**SALES BULLETIN  
No. 0119**

**Introduction of the New C22  
Chain-Drive Transmission**

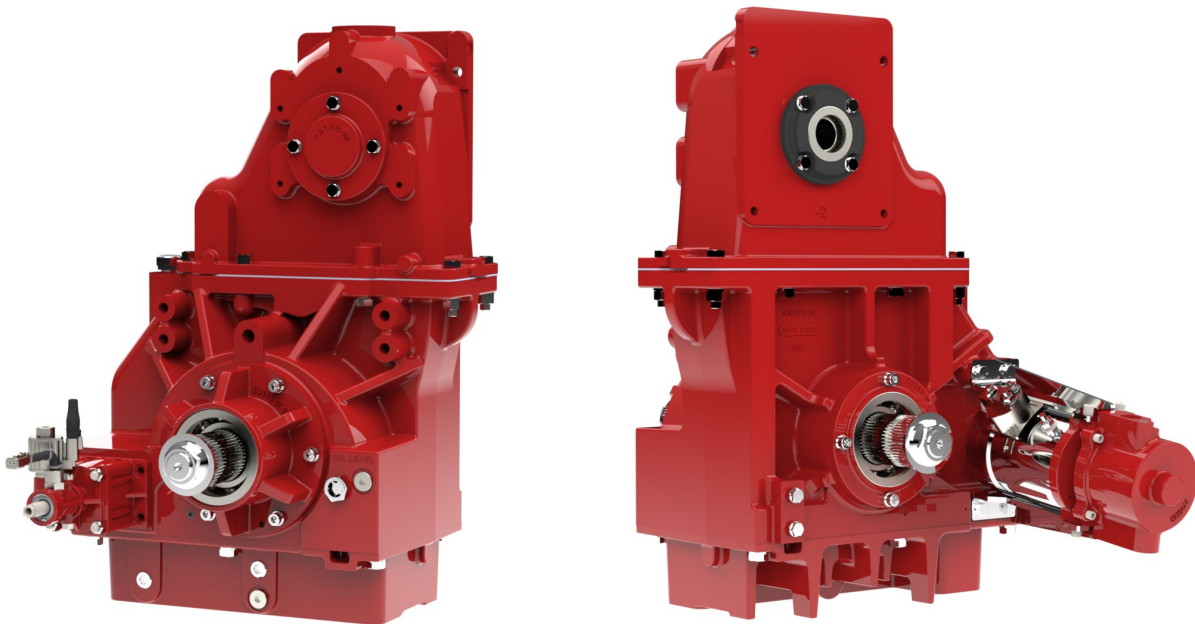
Continuing our innovations and product enhancements, Waterous introduces the new C22 Chain-Drive Transmission that will replace the current C20 Chain-Drive Transmission on orders beginning January 1, 2023. The C22 Generation allows for Waterous pumps/transmission configurations to fit into medium-duty type apparatus. Other features and enhancements are listed below:

- Smaller size fits between medium-duty chassis frame rails
- Increased shaft torque rating: Increased from 16,000 to 19,000 ft-lbs
- Higher driveline speed capability using high-speed ball bearings
- Robust housing and improved structural integrity
- Improved mounting application of primer – angled at 8 degrees to improve draining
- Electronic tachometer option is not available.
- Interchangeability between the C20 Transmission using the same chain widths, ratios and drops
- Optional transmission oil cooler kit
